Memorandum

Correspondence # TTCES-PTLD-2024-006

Subject: **Visual Impact Assessment of Key Observation Points 1, 3, and 5**

Tetra Tech understands that Carriger Solar, LLC (Applicant) is developing the Carriger Solar Project (Project), a solar photovoltaic (PV) electric generating facility that includes 160 (MW) of solar energy and 63 MW of battery energy storage in Klickitat County, Washington. The Applicant is seeking a Site Certification Agreement from the Washington Energy Facility Siting Council (EFSEC).

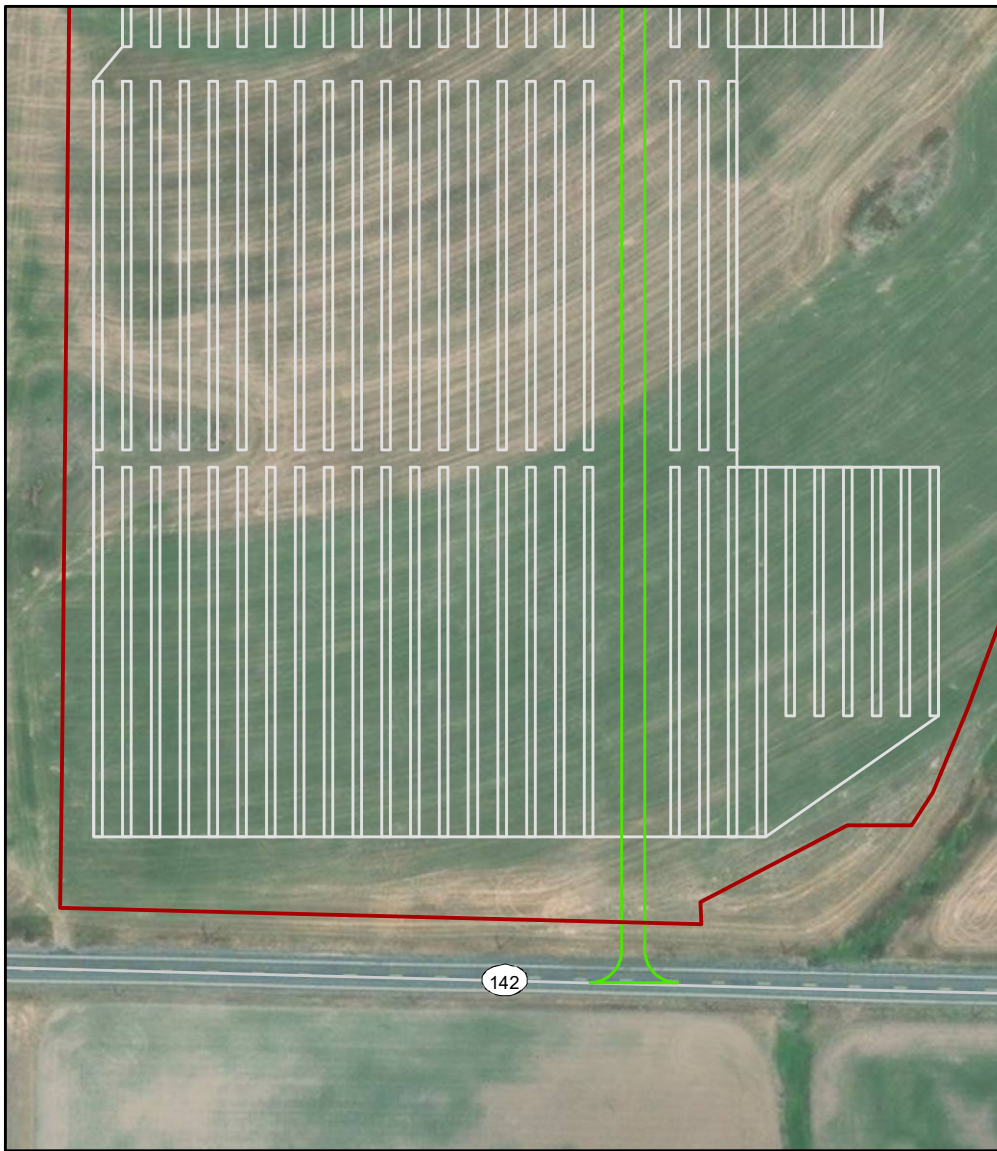
- Fence Design: The Applicant has revised the Project's perimeter fencing design which is shown in Figure 4 and includes an 8-foot-high fence with no barbed-wire and utilizes 6-inch wire mesh opening game fencing. This fence design is similar to fencing design approved by Washington Department of Fish and Wildlife for other solar projects in Washington State. Per the National Electric Code (NFPA 70) requirements, fencing is required to be installed around the Project solar arrays to restrict public access and must have a minimum height of 7 feet with 1 foot of barbed wire along the top, or 8 feet if no barbed wire is used.

- Modification of the fence design
 - Fence Design: The Applicant has revised the Project’s perimeter fencing design which is shown in Figure 4 and includes an 8-foot-high fence with no barbed-wire and utilizes 6-inch wire mesh opening game fencing. This fence design is similar to fencing design approved by Washington Department of Fish and Wildlife for other solar projects in Washington State. Per the National Electric Code (NFPA 70) requirements, fencing is required to be installed around the Project solar arrays to restrict public access and must have a minimum height of 7 feet with 1 foot of barbed wire along the top, or 8 feet if no barbed wire is used.

Figure 1
Layout Changes at KOP 1

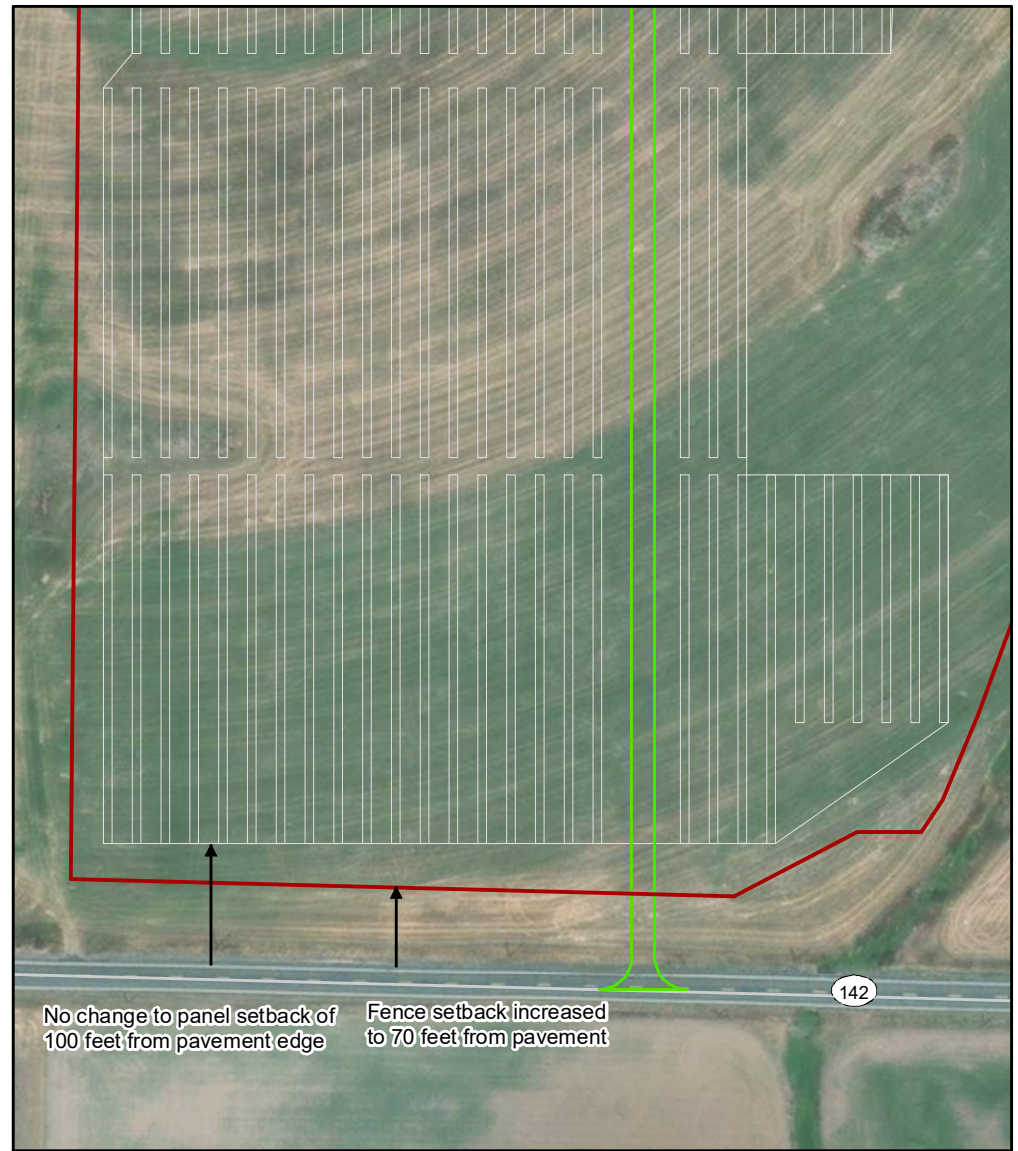
- KOP 1: Along the north side of SR-142, the Applicant has increased the distance the Project fence is setback from the edge of the highway road pavement. The original location of 40 feet has been increased to 70 feet from the edge of pavement. See Figure 1. No change has occurred to the location of the panel arrays which are setback 100 feet from the edge of the road pavement.
- KOP 3: At the northern end of Knight Road, where the Project solar arrays are located on both the east and west side of the road, the Applicant has increased the setback distance of the Project fence from the edge of the road pavement on both sides to 100 feet. This is an increase from the original

- Increase the setback of the fence along SR-142; and
 - KOP 1: Along the north side of SR-142, the Applicant has increased the distance the Project fence is setback from the edge of the highway road pavement. The original location of 40 feet has been increased to 70 feet from the edge of pavement. See Figure 1. No change has occurred to the location of the panel arrays which are setback 100 feet from the edge of the road pavement.

Fenceline setback from SR 142 increased by 30 feet (minimum setback now 70 feet from road pavement, panels set back 100 feet).

Figure 2
Layout Changes at KOP 3

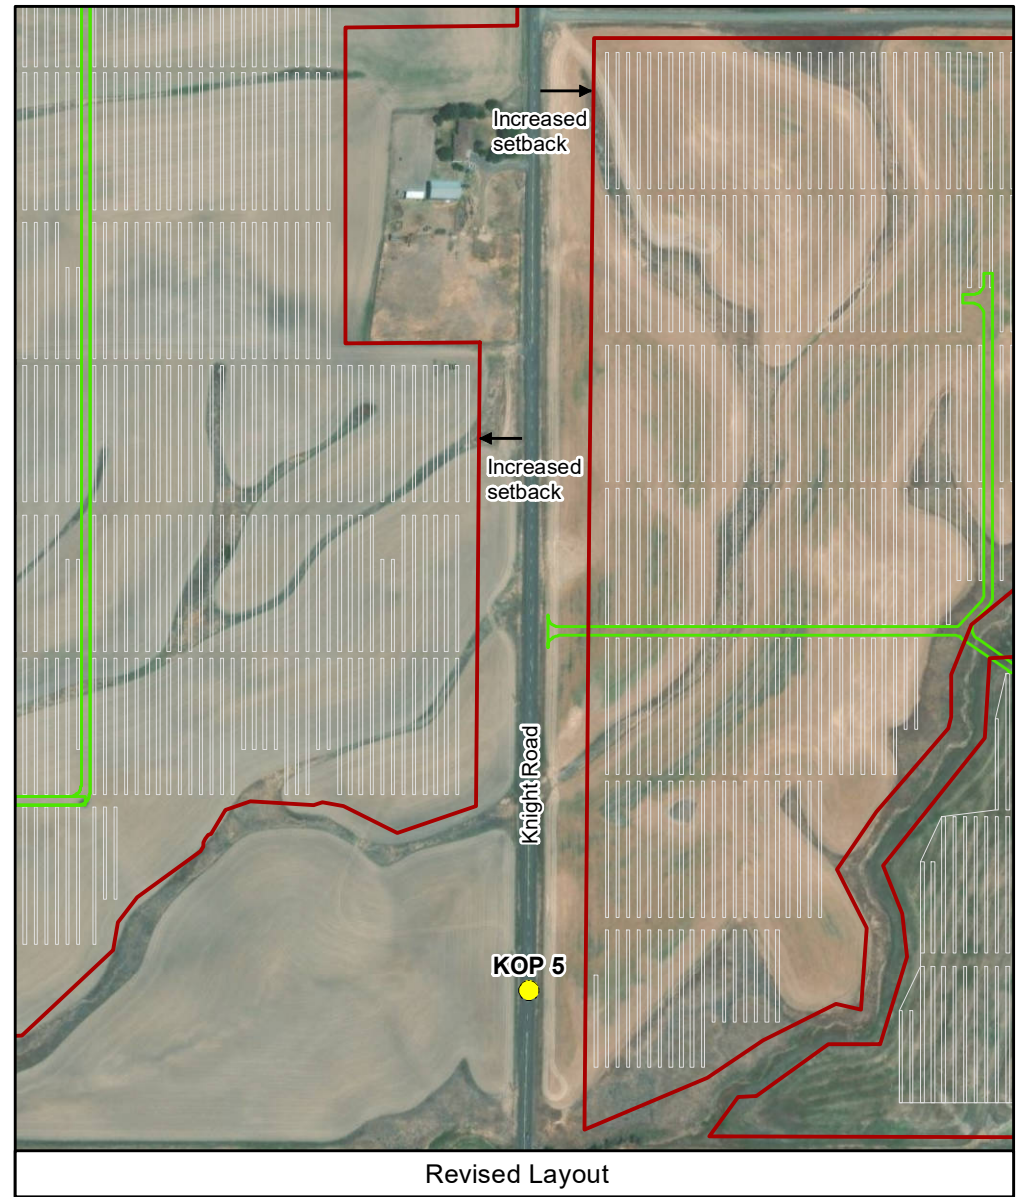
setback of 25-40 feet from the edge of the pavement. See Figure 2. By increasing the fence distance from the roadway, the solar panels have also been setback to a distance of 120 to 160 feet from the road pavement, depending on the location of the solar array (an increase from the original distance of 50 to 70 feet).

- Adjustments to the project layout to increase the setback of the project fence and solar panels along Knight Road:
 - KOP 3: At the northern end of Knight Road, where the Project solar arrays are located on both the east and west side of the road, the Applicant has increased the setback distance of the Project fence from the edge of the road pavement on both sides to 100 feet. This is an increase from the original setback of 25-40 feet from the edge of the pavement. See Figure 2. By increasing the fence distance from the roadway, the solar panels have also been setback to a distance of 120 to 160 feet from the road pavement, depending on the location of the solar array (an increase from the original distance of 50 to 70 feet).

Fenceline and panels setback from Knight Road increased by 25-40 feet (minimum fence setback 100 feet from road pavement, panels setback 120 to 160 feet from pavement).

Figure 3
Layout Changes at KOP 5

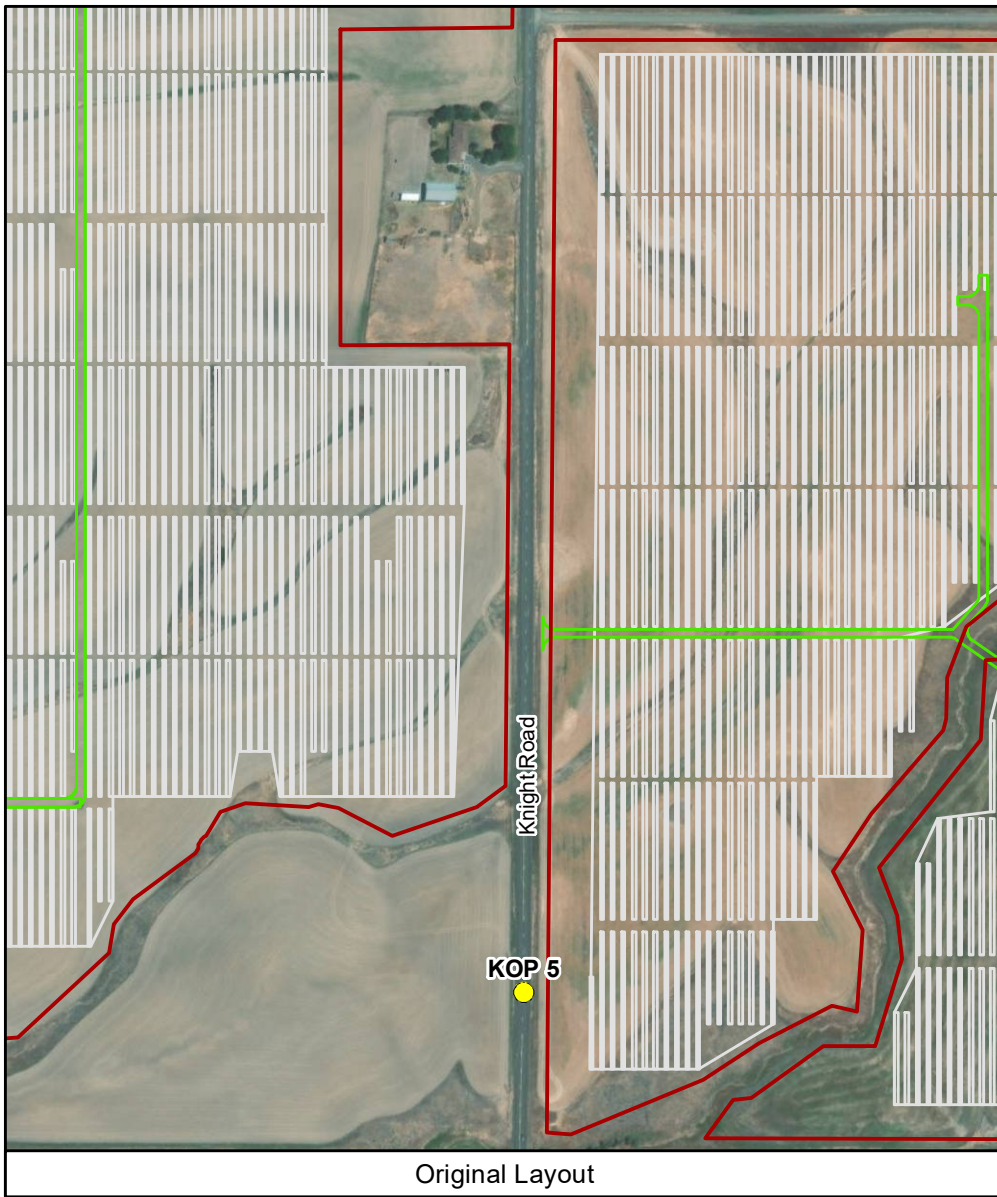
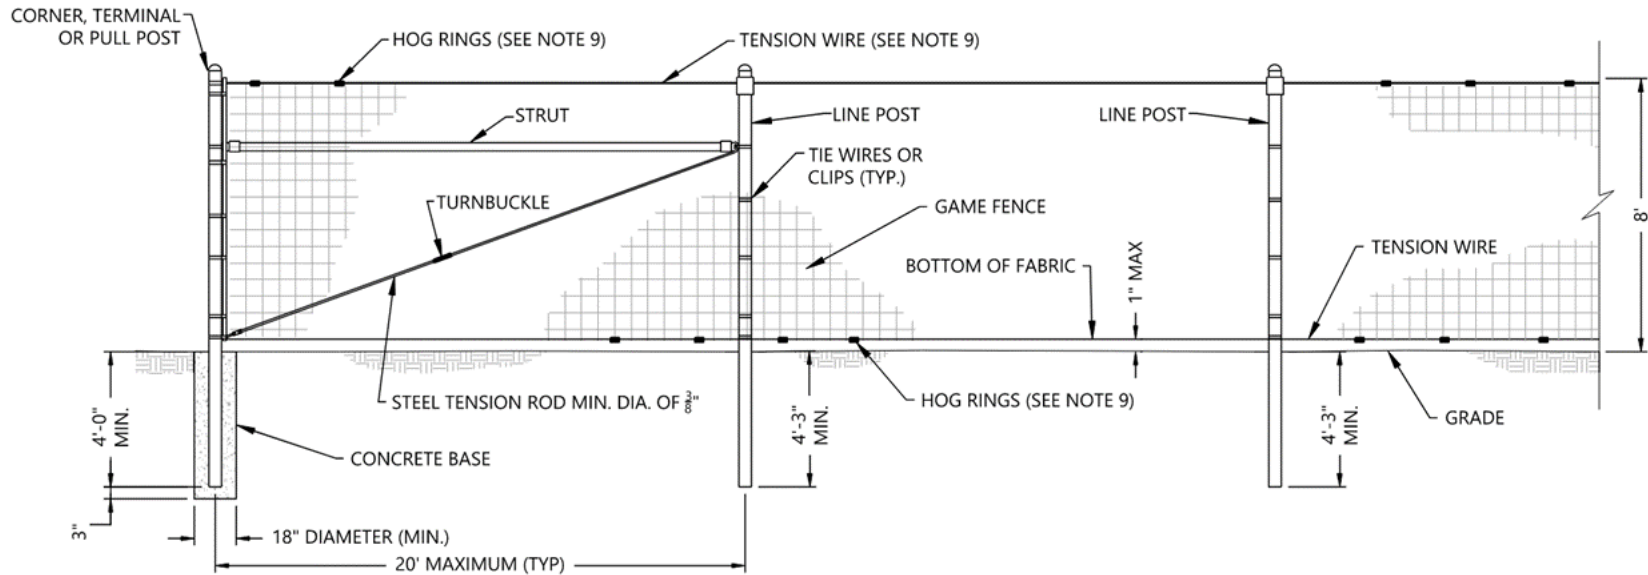
- KOP 5: Along the south end of Knight Road, where the Project solar arrays are located on both the east and west side of the road, the Applicant has increased the setback distance of the Project fence from the edge of the road pavement on both sides to 100 feet. This is an increase from the original setback of 25 to 40 feet from the edge of the pavement. See Figure 3. By increasing the fence distance from the roadway, the solar panels have also been setback to a distance of 120 to 150 feet from the edge of the road pavement, depending on the location of the solar array (an increase from the original distance of 50 to 85 feet).

- KOP 5: Along the south end of Knight Road, where the Project solar arrays are located on both the east and west side of the road, the Applicant has increased the setback distance of the Project fence from the edge of the road pavement on both sides to 100 feet. This is an increase from the original setback of 25 to 40 feet from the edge of the pavement. See Figure 3. By increasing the fence distance from the roadway, the solar panels have also been setback to a distance of 120 to 150 feet from the edge of the road pavement, depending on the location of the solar array (an increase from the original distance of 50 to 85 feet).

Fenceline and panels setback from Knight Road increased by 25-40 feet (minimum fence setback 100 feet from road pavement, panels setback 120 to 150 feet from pavement).

FIGURE 5 KOP 1

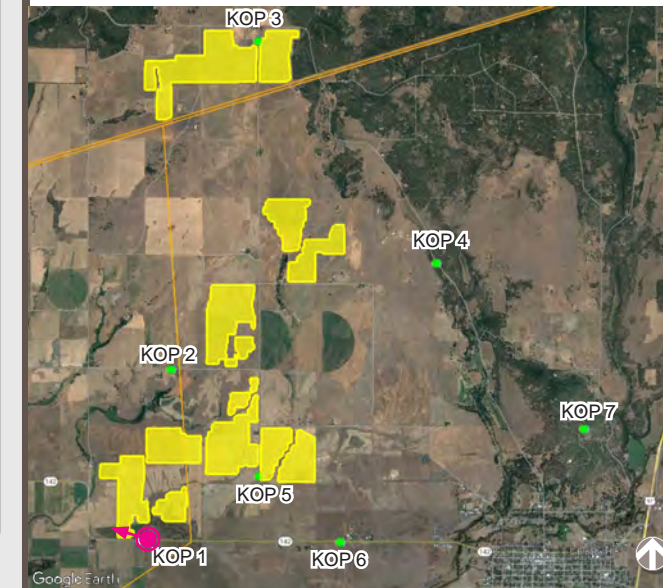
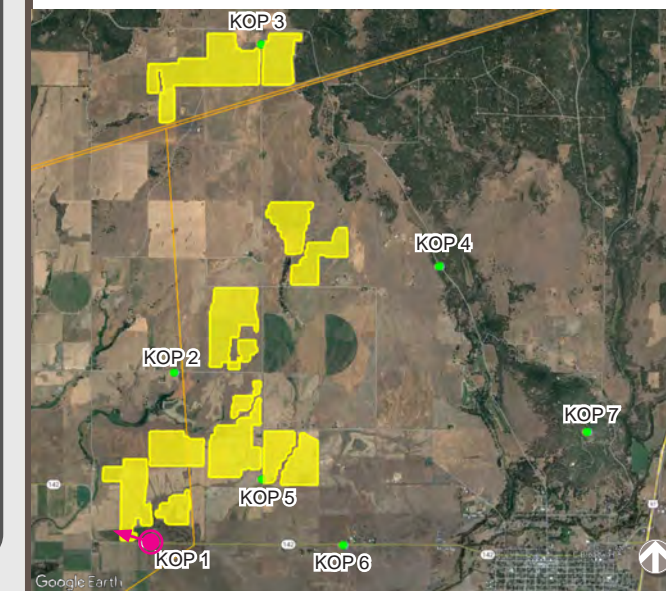
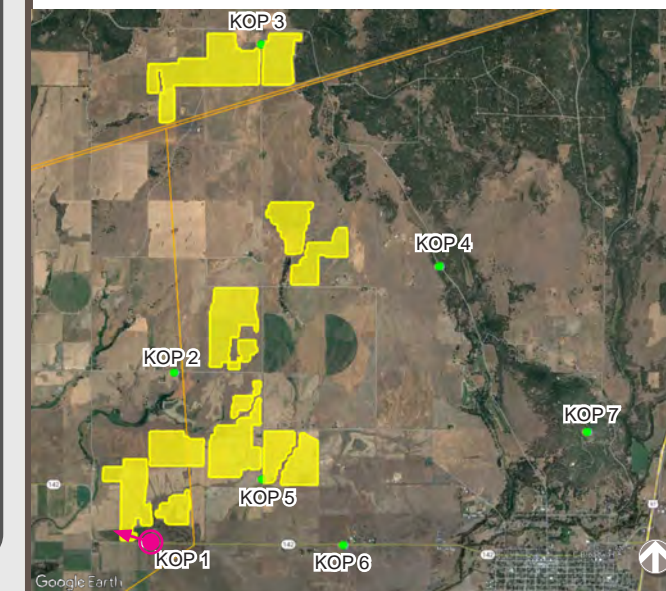
Project's MPE. Figure 5 presents the original simulated view of Project components from KOP 1. Figures 6 and 7 present the updated simulated view of the Project components, with the fence setback 30 additional feet. Figure 6 depicts the view of the panels at flat orientation while Figure 7 depicts the view of the panels at maximum tilt, facing west prior to sunset.

During the majority of the day, the panels will be oriented closer to a horizontal alignment that allows views through the Project site, reducing attention to and contrast from the Project (see Figure 6). Therefore, during the majority of the day, the panels would introduce a weak contrast. When the panels are at maximum tilt (Figure 7), the Project would begin to attract attention to the casual observer and begin to co-dominate the landscape which would indicate the introduction of a moderate contrast per the BLM contrast rating definitions. However, by setting the panels back from SR-142 by 100 feet, and increasing the fence set back to 70 feet from the roadway, the view orientation focuses either down the roadway or over the panels toward the hills and mountains in the background. The visual experience would be short-term for travelers and the Project would attract little attention from drivers on SR-142. Therefore, the Project would introduce weak contrast for travelers on SR-142.

FIGURE 8

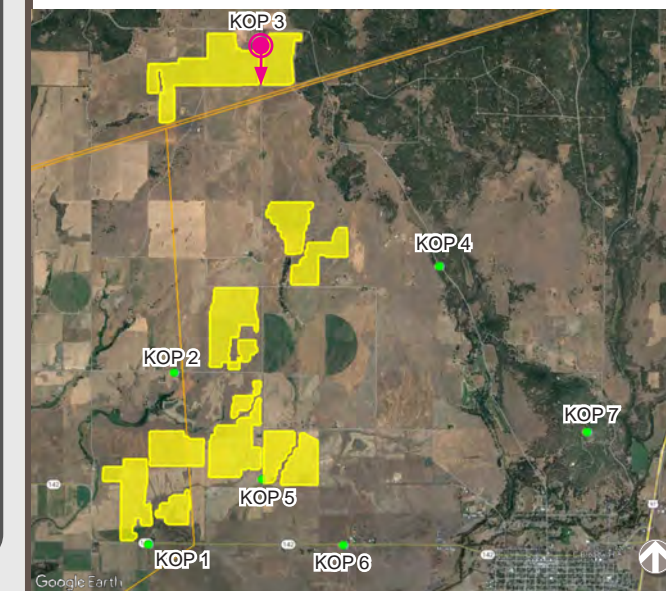
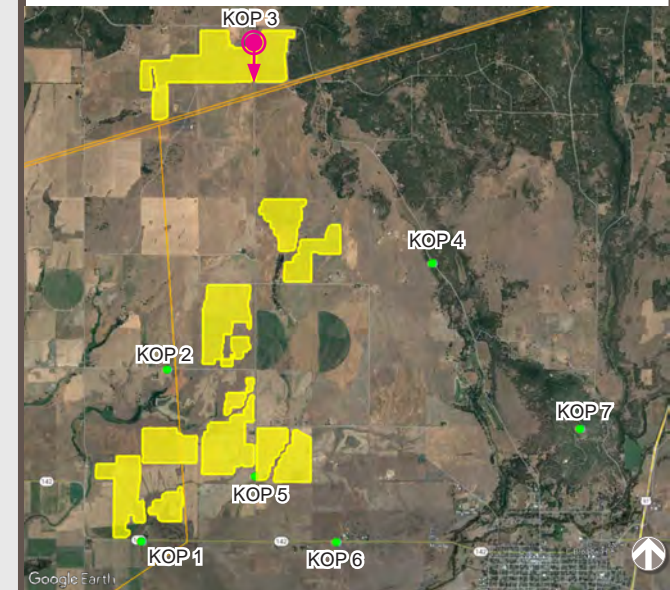
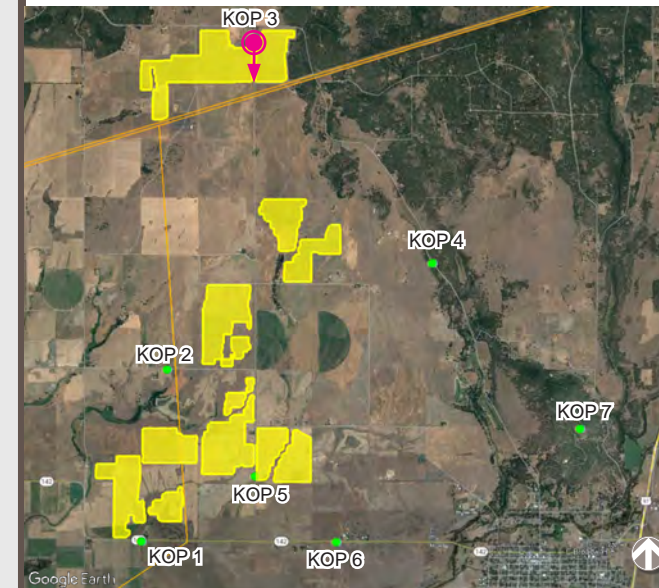
KOP 3 represents a view of the Project for drivers traveling south on Knight Road and the non-project participating residences north of this viewpoint. This KOP also represents views of the north portion of the MPE. Figure 8 presents the original simulated view of Project components from KOP 3. Figures 9 and 10 present the updated simulated view of the Project components, with increased setbacks. Figure 9 depicts

the view of the panels at flat orientation while Figure 10 depicts the view of the panels at maximum tilt near sunset (facing west).

During the majority of the day, the panels will be oriented closer to a horizontal alignment that allows views through the Project site, reducing attention to and contrast from the Project (see Figure 9). While the Project would begin to attract attention to the casual observer, the portion of the Project that would be visible would not dominate the landscape the majority of the day when the panels will be oriented closer to a horizontal alignment. In the maximum tilt orientation (Figure 10), the Project would begin to attract attention to the casual observer and begin to co-dominate the landscape along with the other existing structures in the vicinity that provide horizontal and vertical lines. Beginning to dominate the landscape is a “moderate” level of contrast per the BLM contrast rating definitions. The maximum tilt visual experience would short-term both because of the short amount of time each day the panels would be at maximum tilt orientation and for the short amount of time travelers would see the panels while driving down Knight Road. In addition, with the increased set back from the roadway, the view orientation focuses either down the roadway or over the panels toward the hills and mountains in the background. The viewer’s focus will be on the road and existing transmission lines and fence lines, and the Project no longer demands attention or dominates the landscape due to the increased setbacks and modified fence design. Therefore, the Project would introduce moderate contrast for travelers on Knight Road at KOP 3.
